Solicitation Solicitation Amendment

1. Amendment Number A01 to Solicitation Number 360070-22-A-0023		Date 08/17/2022		
2a. Facility DAVENPORT, FL - MAIN OFFICE		2b. Project E54635 Building and Parking Expansion		
3a. Offeror Name and Address		3b. Issued By EASTERN FCCMT 7029 ALBERT PICK RD GREENSBORO, NC 27409-9521		
		3c. Contact NIKHIL SONI Nikhil.Soni@usps.gov

5. Description of Amendment: Amendment A01 serves to provide the following: - Pre-Proposal Meeting minutes (Attached) - Revised Offer and Award Page (Please use this page with your proposal) (Attached) - Changes to Specifications (Changes to Alternates) (Attached) - Changes to Drawings (Attached) - Response to Supplier Questions (Attached) All other terms and conditions remain unchanged.

Pre-Proposal Conference Notes.
Davenport MPO Building & Parking Expansion
August 10, 2022 – 1:00 PM

IRRIATION PLAN

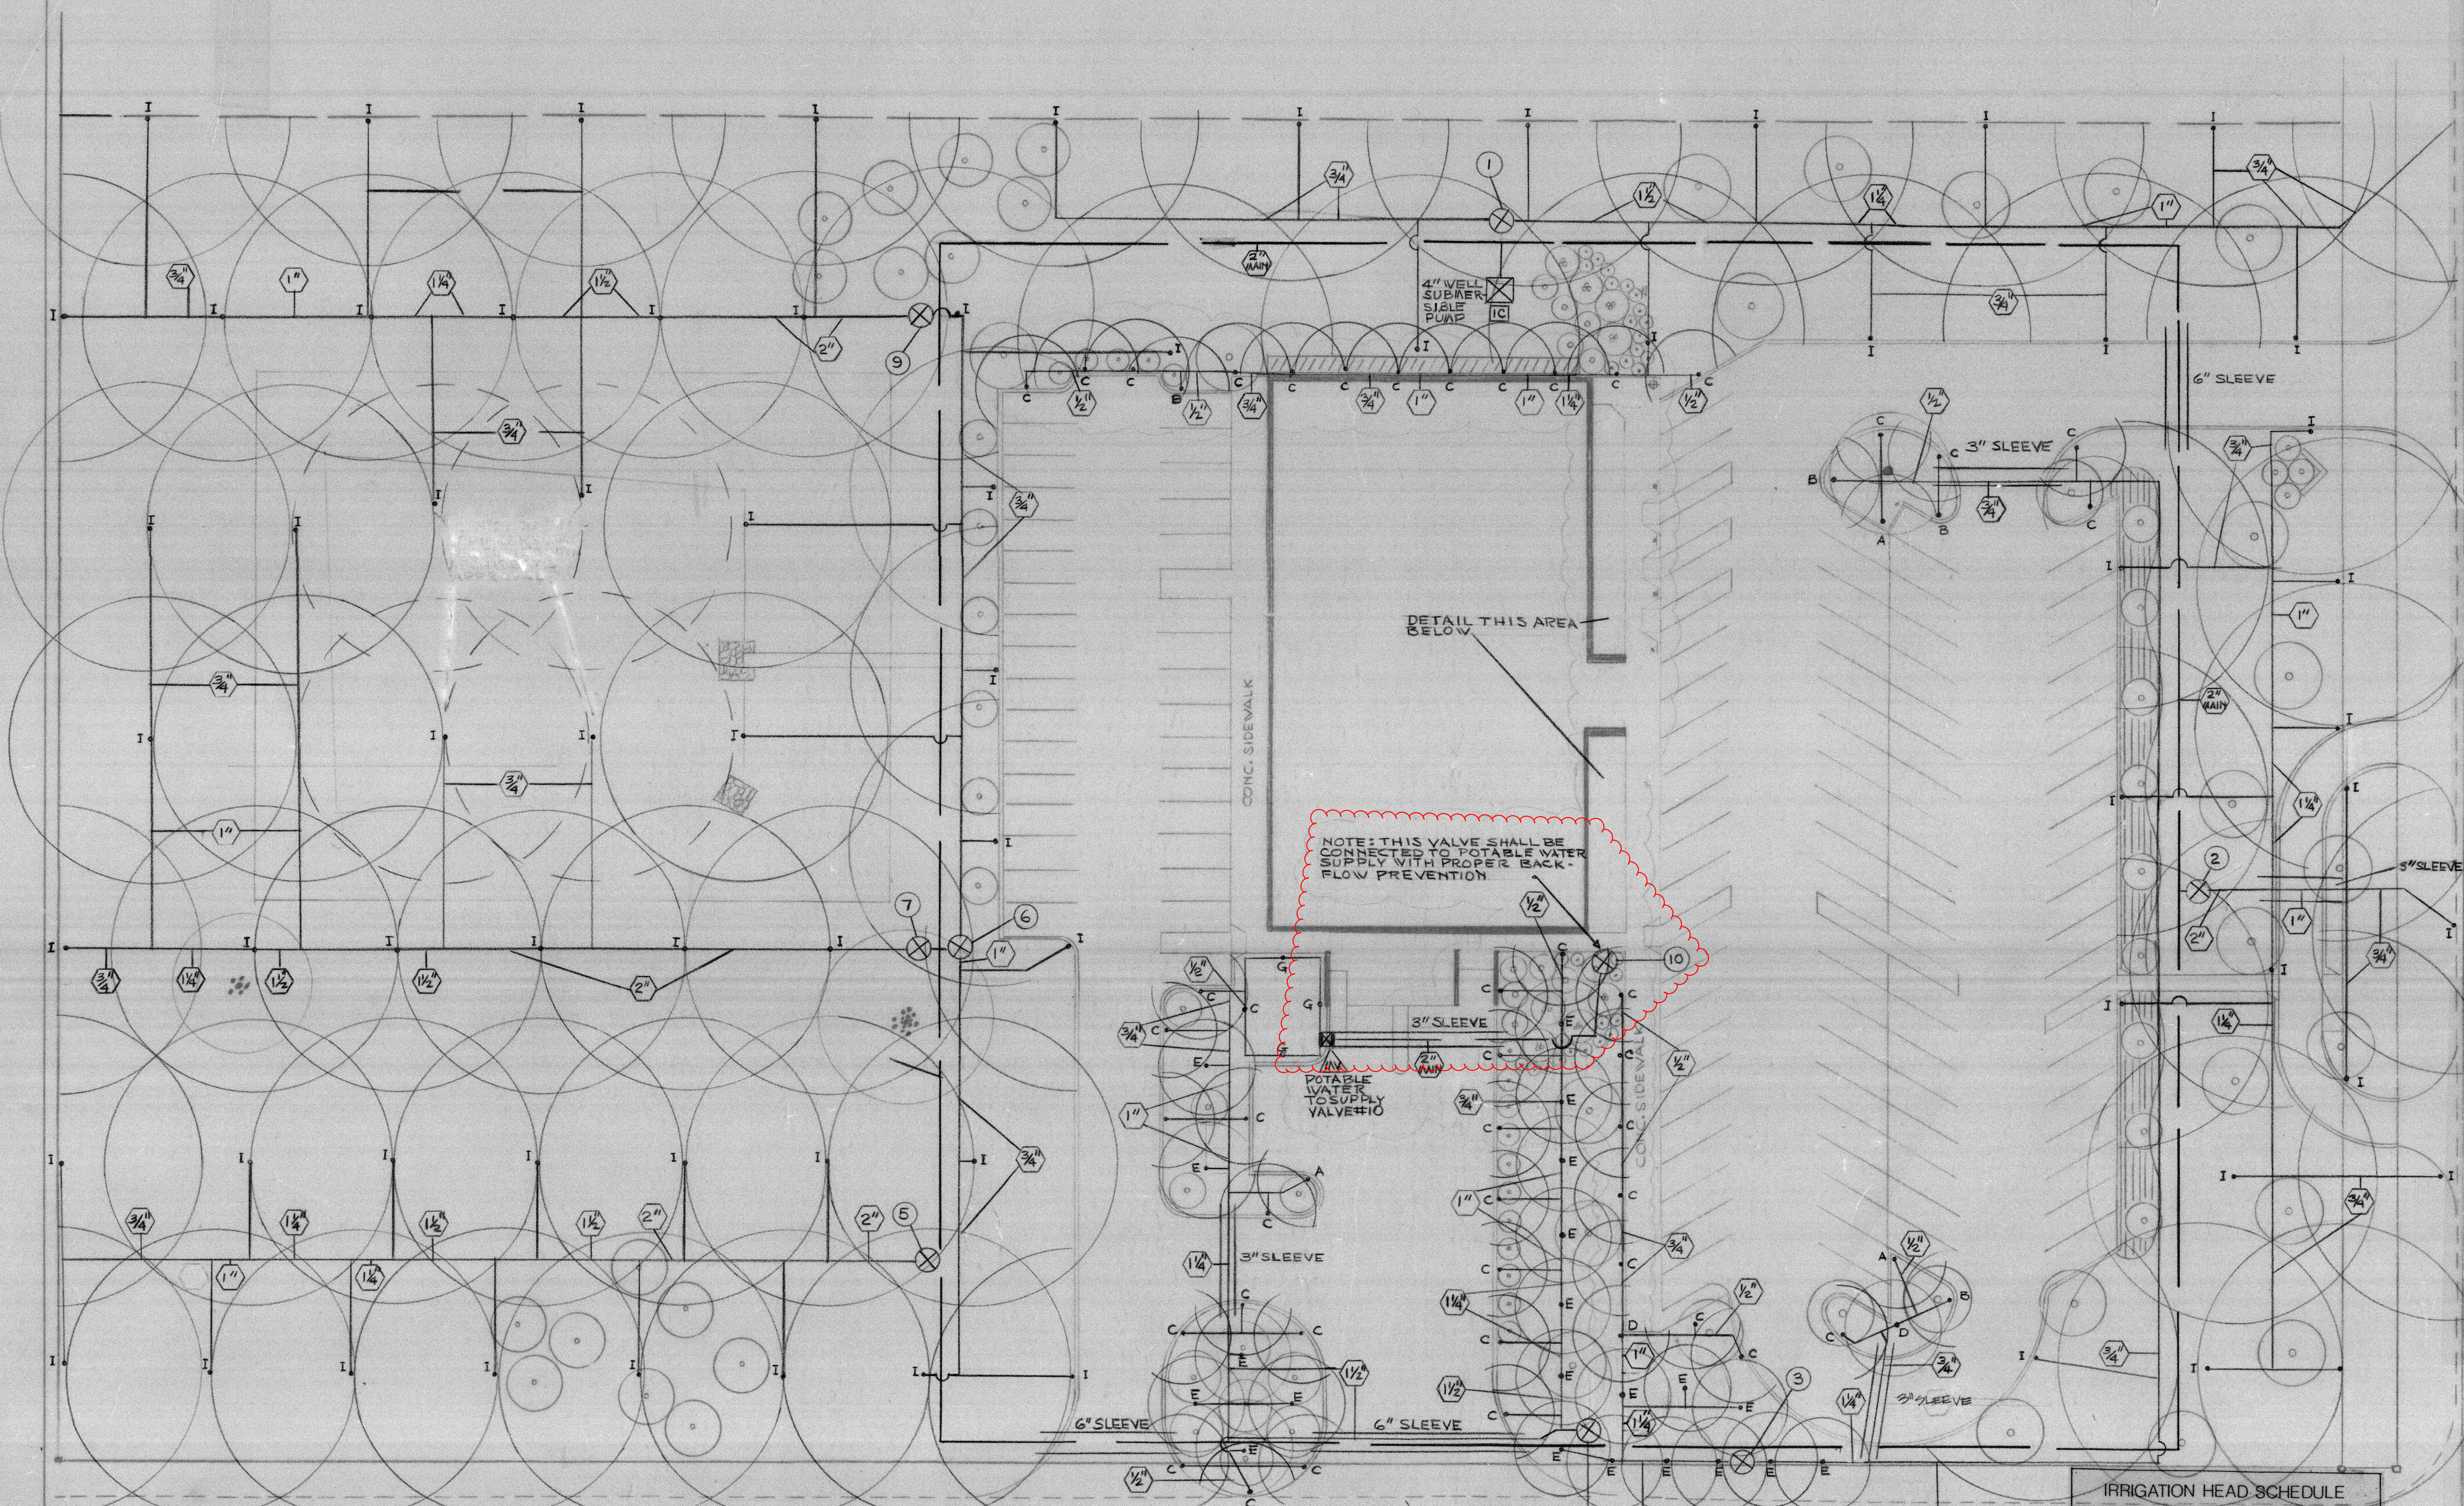
Question: Irrigation Well: Please clarify the intent with the irrigation well and pump location with regards to Deductive Alternate #1

- All electric connections to Div. 16 Power Source shown on sheet E-1, all interconnection of electric valves, time-clock and pump starter are a part of this irrigation contractor's work.
